# Introducing two proposals: Amendments for UN-Regulation for ALKS [157]

# Proposal 1: Speed increase up to 130 km/h

# Proposal 2: Lane change functionality

## High-level principles for lane change

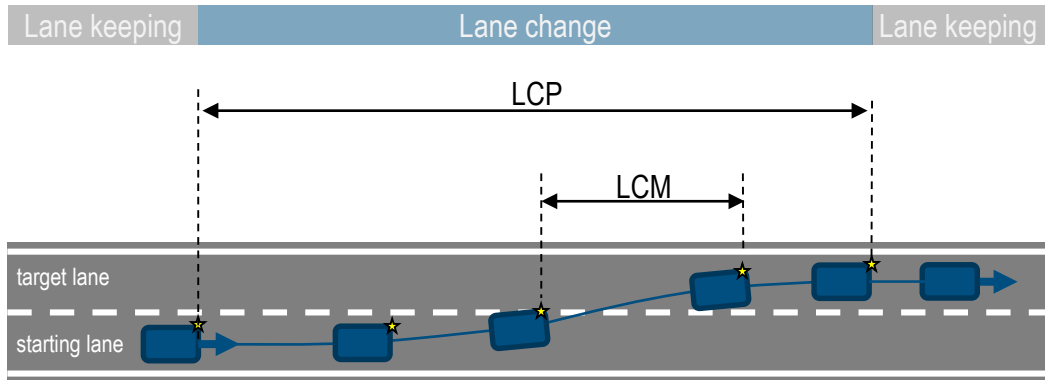
- No violation of traffic rules
- Only be performed:
  - if system has sufficient information about surrounding to front, side & rear,
  - if traffic situation allows it and if other road users are not endangered
    - LC shall not result in collision with another vehicle or road user in predicted path
    - Approaching vehicle in target lane should not have to unmanageably decelerate
- Intention of performing LC shall be indicated at all times in unambiguous way
  - Indicated in advance
  - Changing of lane one continuous movement
  - Take as long as necessary, but completed as quickly as possible
- Vehicle shall always end up in a single lane of travel
- ...

## Key details (GRVA/2020/33) - continued

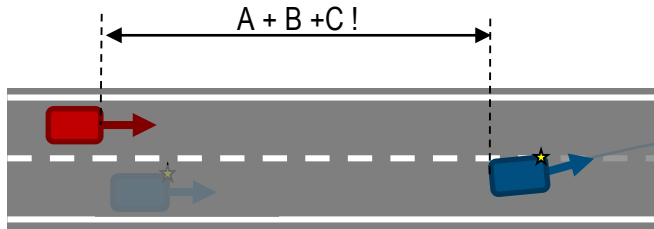
Assessment of target lane:

- LCP only initiated if approaching vehicle in target lane not forced to **unmanageably decelerate**
- Factors taken into account:
  - A: Maximum deceleration,
  - B: Reaction time &
  - C: Safety gap
